RE: Modwash - Eubank
Grading & Drainage Plans
Engineer's Stamp Date: 02/07/23
Hydrology File: K20D060

Based upon the information provided in your submittal received 02/08/2023, the Grading & Drainage Plans **are not** approved for Building Permit and SO19 Permit. The following comments need to be addressed for approval of the above referenced project:

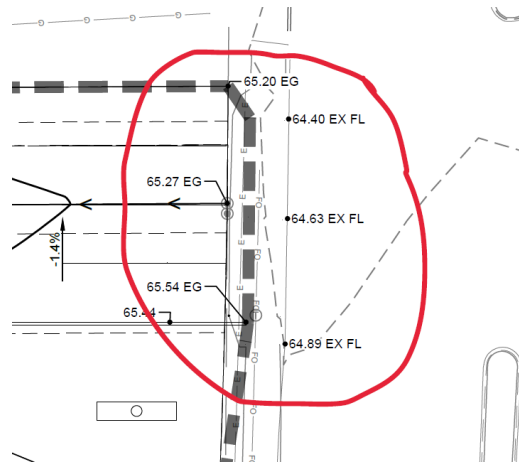
4. Please provide a curb & gutter along the northern side of the proposed driveway on Eubank. This curb is needed to protect the existing metal electrical pole and existing billboard support beams. See photo above.
5. On Sheet 103, please provide the weir calculations, per DPM Article 6-16(A), for the curb cuts and sidewalk culverts. A coefficient of 2.7 is typically used for the weir equation $Q = CLH^{2/3}$.

SHEET NUMBER:
C-103

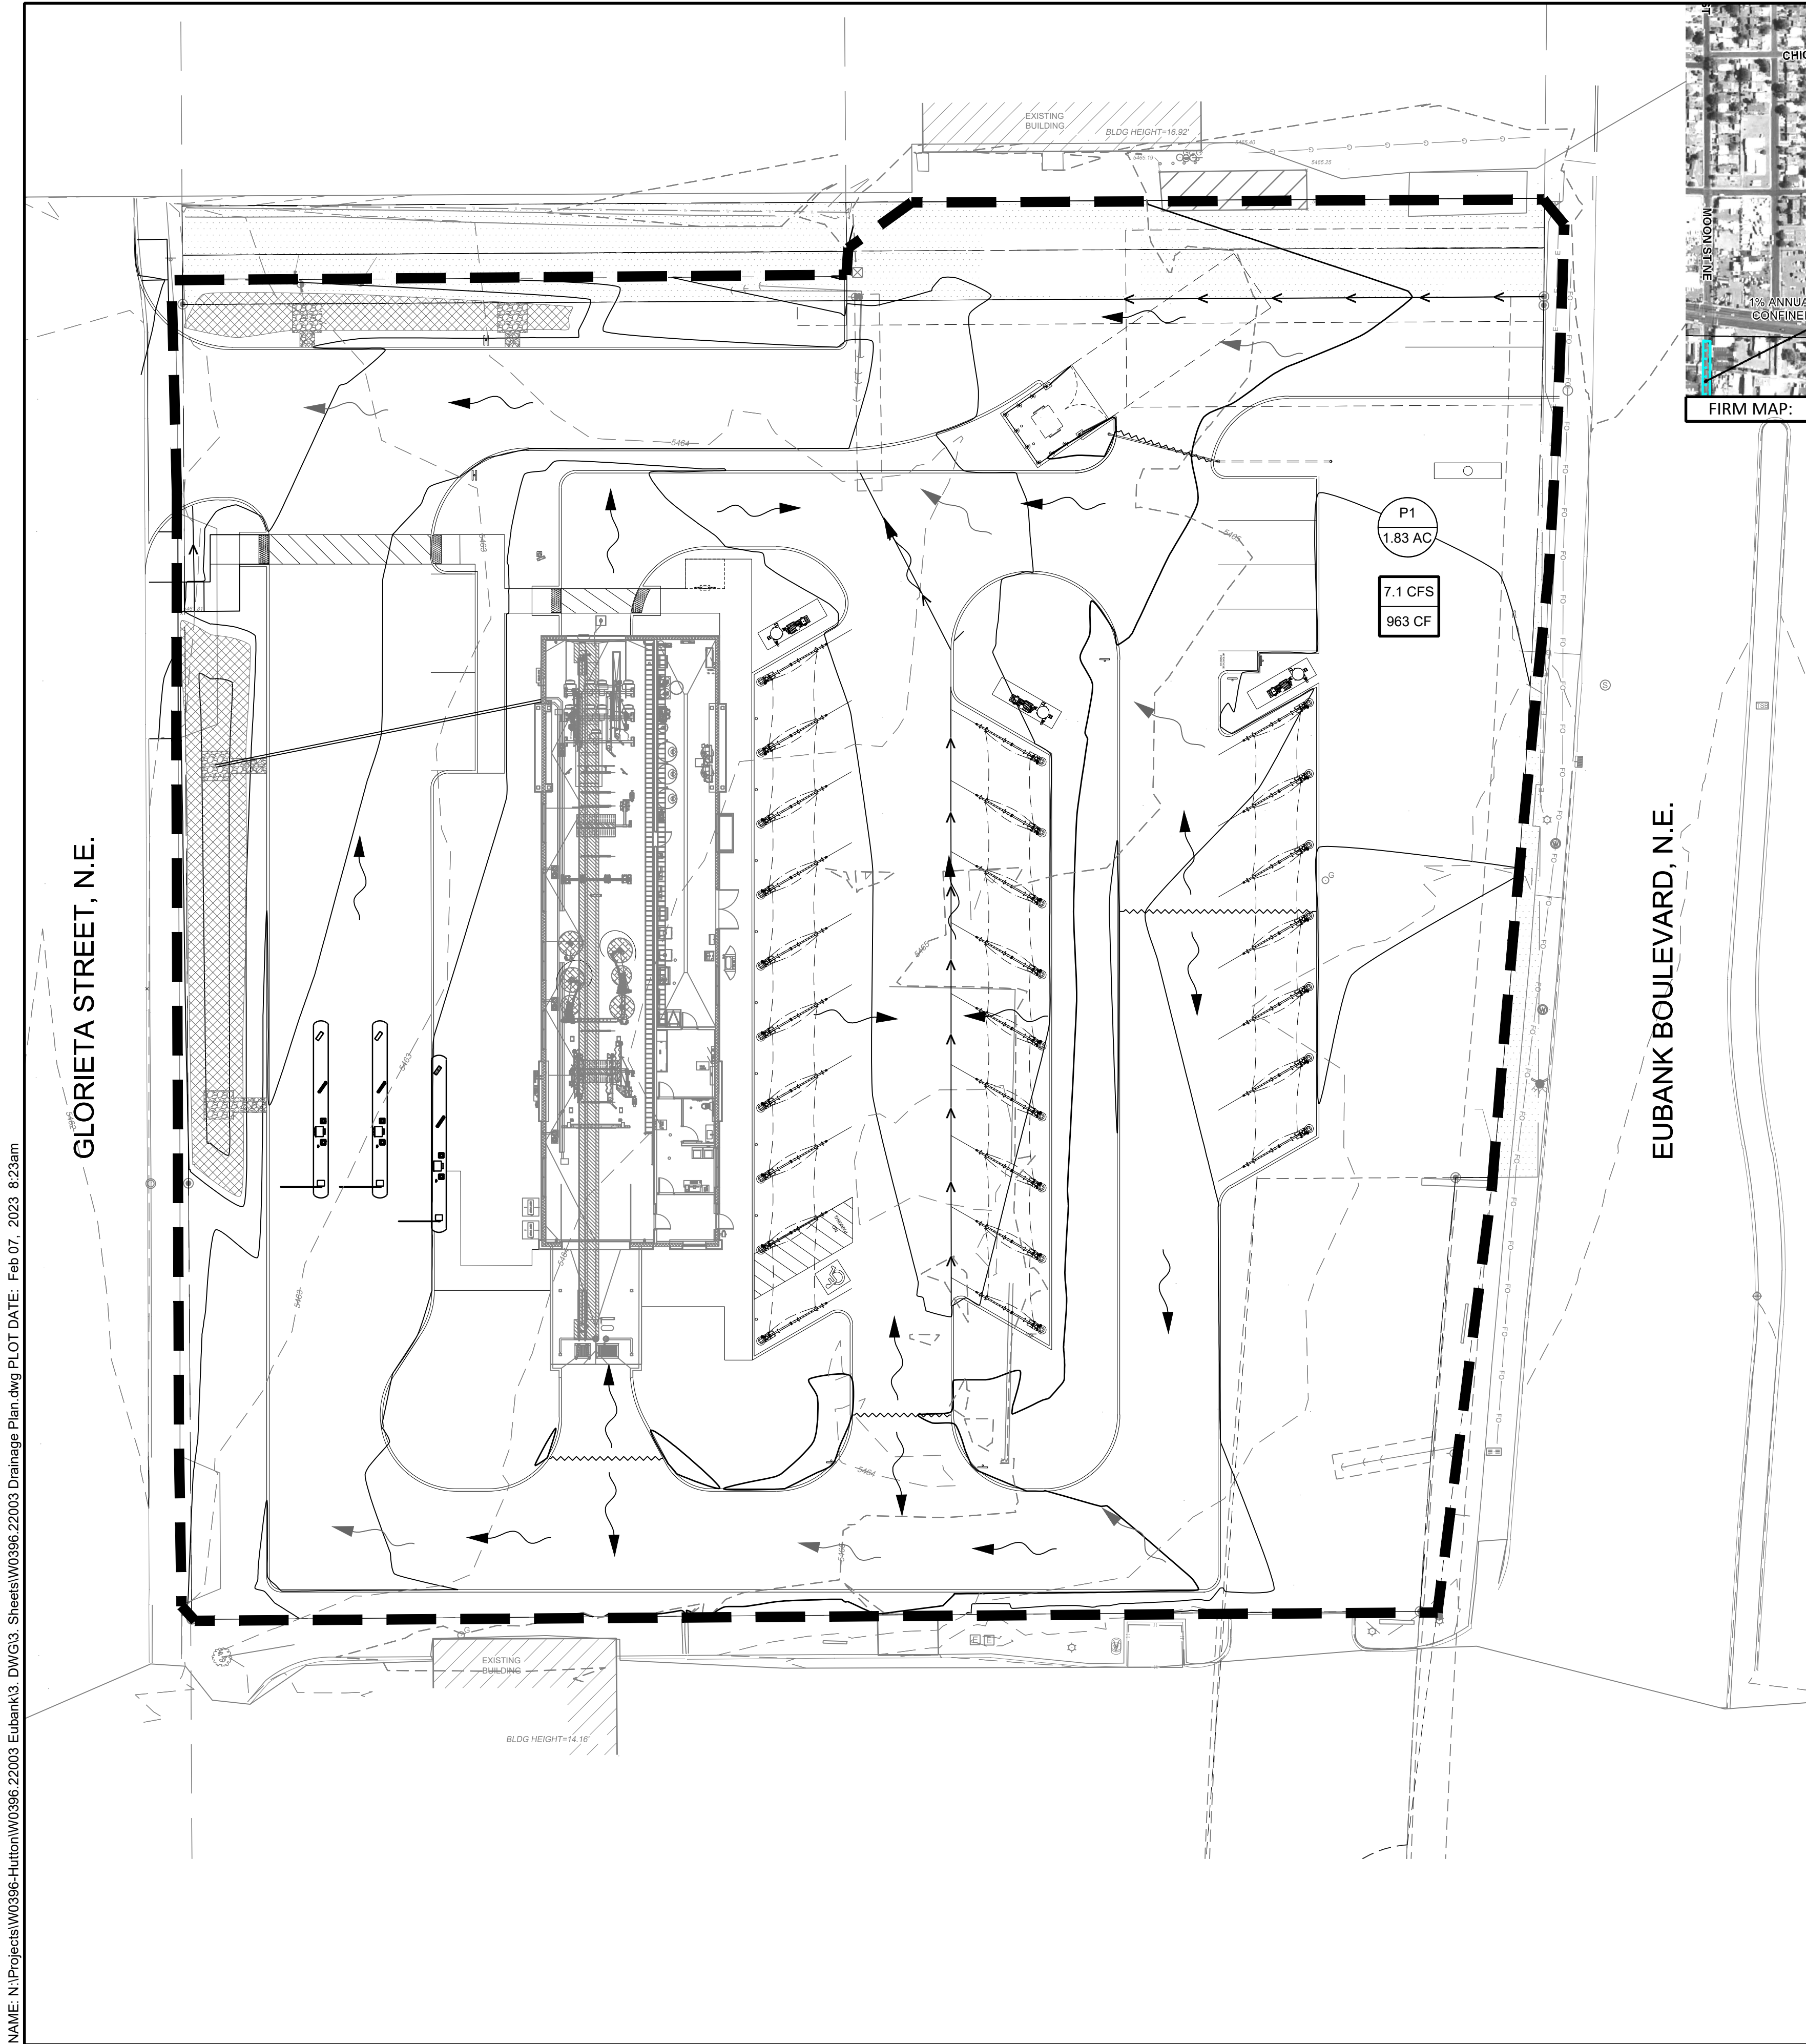
2. On Sheet C-103, Please insure that the drainage flow arrows match the drainage flow arrows on Sheet C-104. There are a few that do not match.
3. Since there is curb & gutter on the project, please remove the existing drive pad on Eubank and provide a private curb return per CoA Detail 2426.
